2210545

Appendix A – Response to Submissions

Extracts from public authority submissions and submissions from organisations, including stakeholder and interest groups, received in relation to SSD-32927319 and a response to each of these matters has been provided in the sections below.

Figure 1: Extract of Sydney LEP Heritage Map indicating extent of local heritage listing (site boundary in red outline)

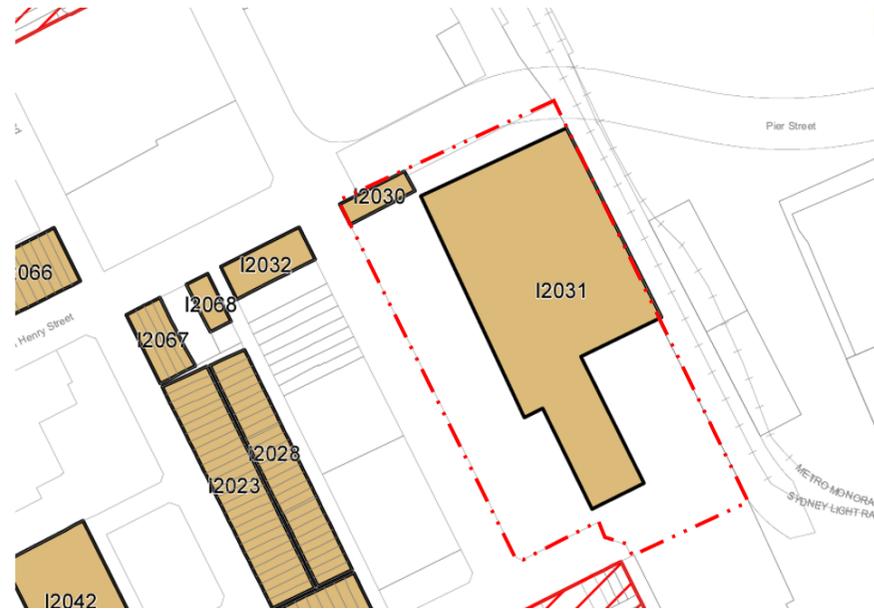
COS -11	<p>3.3.1 Heritage core</p> <p>The Heritage Core should include the whole of the City of Sydney listing which applies to Lot 1, DP 631345, and which includes the following in addition to the heritage buildings:</p> <ul style="list-style-type: none"> • The northeast courtyard and associated Goods Line rail tracks, currently labelled zone 1. • The parcel of land extending from Harris Street to the Switch House, currently labelled as part of zone 2. • The parcel of land extending to Macarthur Street along the entire length of the Switch House, currently labelled as part of zone 2. 	<p>Schedule 5 of the LEP outlines that the local listing for Powerhouse Ultimo is limited to 'Powerhouse Museum former warehouse buildings, including interiors. Further Heritage Map 008 of the LEP (Figure 1 below) confines the listing to the buildings. As such it is not correct to characterise the local listing as applying to the entirety of the lot.</p> <p>As noted in the Submissions and Amendment Report, the Amended Building Envelopes (Appendix C) remove any proposed building envelope above the State Heritage Items (except in the location of the existing rooftop mezzanine addition above the Switch House) to clarify that no new buildings are proposed in these zones.</p> <p>We note that there are numerous examples within the City of Sydney local government area, including within the Sydney CBD and Pyrmont Peninsula, where development on,</p>

As mentioned at the beginning of this section, additional height above the heritage buildings (and the whole of the heritage listed lot) is assumed to be not permitted or encouraged. It is considered contrary to objectives (a) and (b) of Clause 4.3 of the Sydney Local Environmental Plan 2012. The proposed height would not represent design excellence in relation to the heritage items, therefore no additional bonus height should be granted for the 'Heritage Core'. Further, the bonus of 10% for design excellence is not appropriate in this location due to the inherent potential heritage impacts of building additional volume above the heritage items. No additional height should be permitted above the heritage listed buildings, for the following reasons:
